ADDENDUM NO. 2

DATE: January 25, 2024

PROJECT: MAIN GYMNASIUM IMPROVEMENTS
SANDERSON HIGH SCHOOL
5500 Dixon Drive, Raleigh NC 27609

ARCHITECT: **Gürel Architecture, Inc.**
1145B Executive Circle, Cary, NC 27511

SK
NO: **A01**

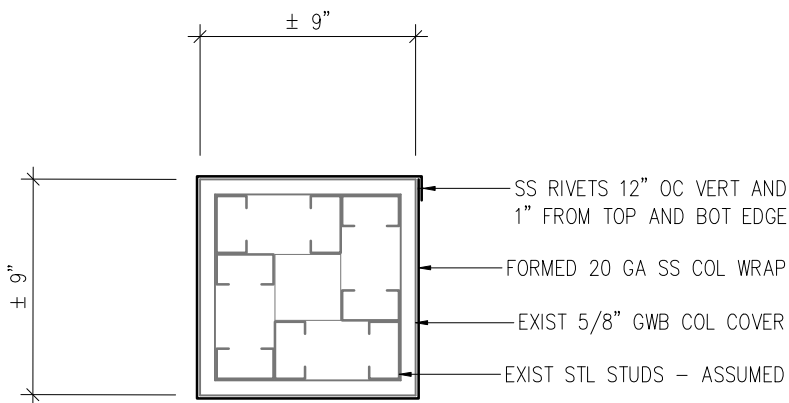
3. Provide stainless steel column wrap on existing column in Corridor 169 as per attached Sketch SK A01.
4. The flooring at the Northeast corner of the Main Gymnasium 172 is revised as per attached Sketch SK A02.

PROVIDE STAINLESS STEEL WRAP AT INDICATED EXISTING ± 9" SQ GWB COLUMN COVER. COVER WRAP SHALL BE 20 GA, 304 STAINLESS STEEL, #4 FINISH, FORMED WITH 1" OVERLAP AND LAMINATED ON EXISTING GWB COLUMN COVER AND SS RIVETED MAX 12" ON CENTER AT VERTICAL CENTER OF OVERLAP WITH MIN 1" TO BOT AND TOP EDGE. THE HEIGHT OF THE COVER WRAP SHALL MATCH CEILING HEIGHT (± 10'-0").

ATTACHMENT A, REFER TO RFI ITEM 3

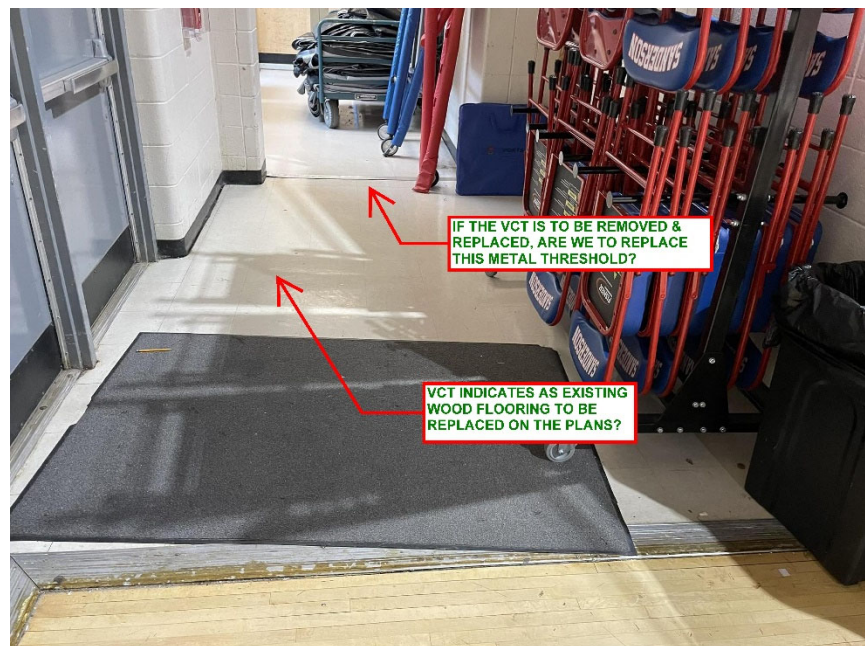
3. There is existing VCT flooring at the NE corner of the GYM (by doors 172.10, .11 & .12) (Reference Attachment A). The plans indicate existing wood flooring to be removed & new wood flooring to be installed in its place? Please review and confirm that the VCT is to be removed and what type of flooring is to be installed in its place, since the depth of the wood flooring system does not appear that it will work at this location.

- 3.2. There is an existing threshold in the picture attachment A attached that is an existing VCT to VCT transition. Please confirm/clarify if this is to be replaced?

[Response: Existing VCT flooring to remain. Please refer to Item 4 of Addendum No. 2.](#)

[Response: Existing threshold at VCT to VCT transition shall remain.](#)
